SUBMITTAL SUMMARY REPORT 33139

PLAN NAME: THE HOME DEPOT - OCALA SOUTH

SUBMITTAL	STARTED	DUE	COMPLETE	STATUS
OCE: Plan Review (DR) v.4	04/30/2026	05/07/2026	05/13/2026	Approved
OCE: Plan Review (DR) v.3	02/26/2026	03/05/2026	03/30/2026	Requires Re-submit
OCE: Plan Review (DR) v.2	01/13/2026	01/21/2026	01/29/2026	Requires Re-submit
OCE: Plan Review (DR) v.1	08/19/2025	09/02/2025	11/13/2025	Requires Re-submit

OCALA #0000
 MAJOR SITE PLAN
 PREPARED FOR
 THE HOME DEPOT
 MARION COUNTY
 FLORIDA

SHEET NUMBER
C-000

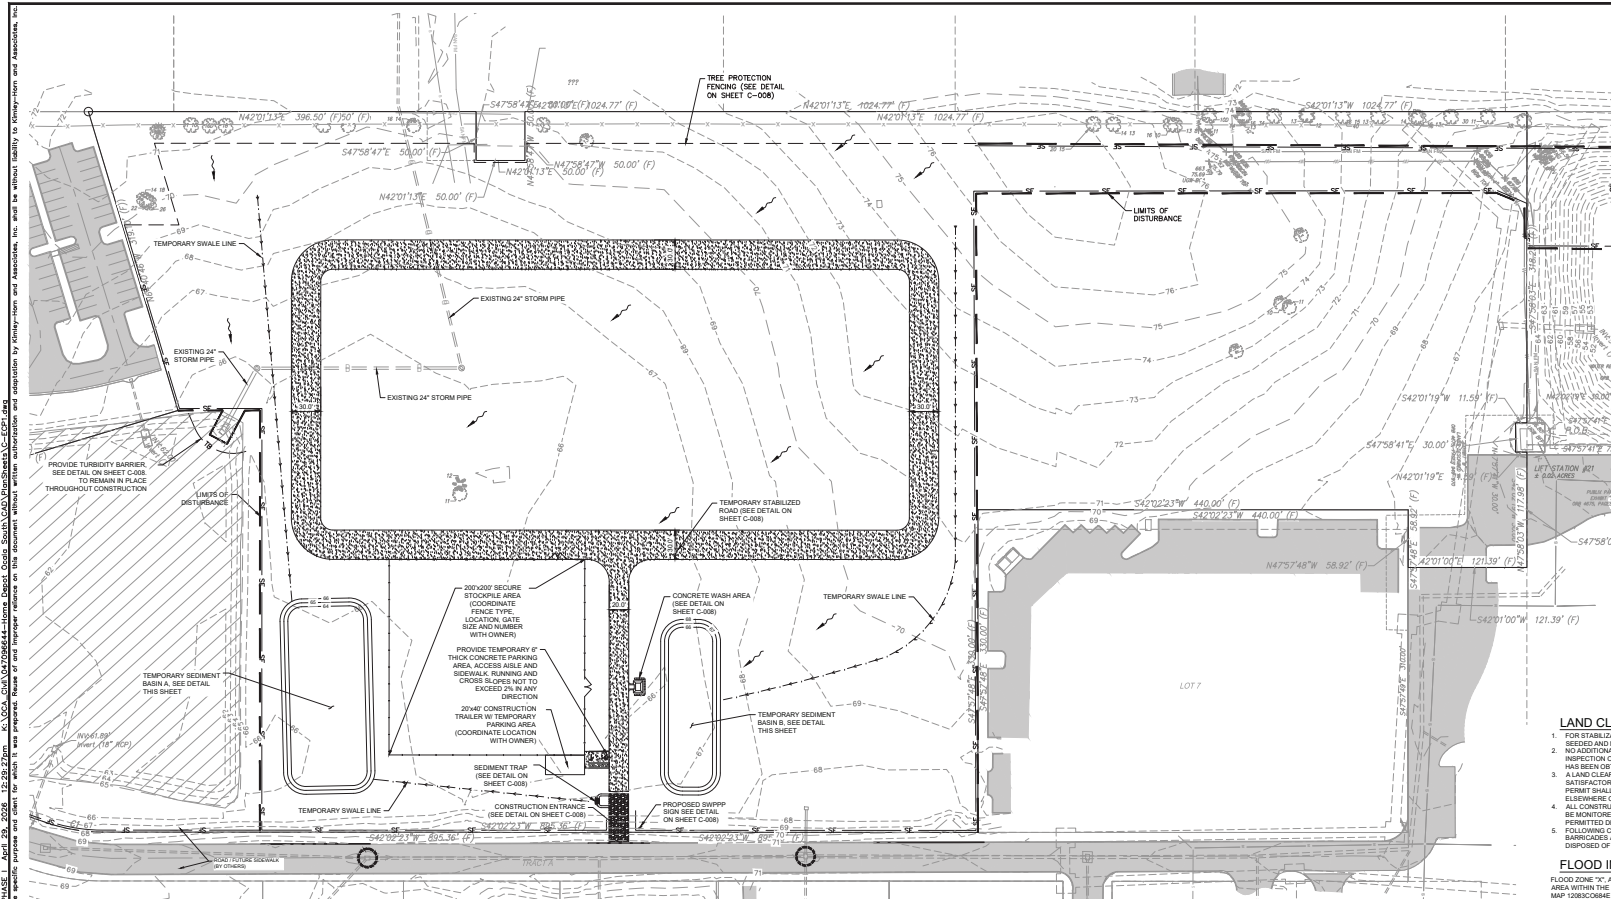
ITEM REVIEW NAME (DEPARTMENT)	ASSIGNED TO	DUE	COMPLETE	STATUS
911 Management (DR) (911 Management)	Janet Warbach	01/21/2026	01/13/2026	Requires Re-submit
<i>Corrections</i>	Additional 911 Comments (Not Resolved) - Sheet C-000 of the Civil Plans still have SW 99th Street Rd listed as SW 99th Street at the top of the sheet.			
Environmental Health (Plans) (Environmental Health)	Evan Searcy	01/21/2026	01/15/2026	Approved
Fire Marshal (Plans) (Fire)	Jonathan Kenning	01/21/2026	01/13/2026	Approved
<i>Comments</i>	Previously Approved			
Growth Services Planning & Zoning (DR) (GS Planning and Zoning)	Kenneth Odom	01/21/2026	01/21/2026	Approved
<i>Corrections</i>	2.12 - Site coverage (Resolved) - 2.12 - Site coverage: Provide list of site coverage in square footage, acreage, and percentage. Including existing and proposed building coverage by intended use with gross floor area, leasable/interior area, existing and proposed gross impervious area.

N/A 2.12.5/1.8.2.D - Concurrency - PRELIM Evaluation Required?
NO 2.12.5/1.8.2.F - Is Concurrency Approval or Deferral Elected? Revise the plan Cover Sheet to provide the following note:
"This proposed project has not been granted concurrency approval and/or granted and/or reserved any public facility capacities. Future rights to develop the property are subject to a deferred concurrency determination, and final approval to develop the property has not been obtained. The completion of concurrency review and/or approval has been deferred to later development review stages, such as, but not limited to, Building Permit review."
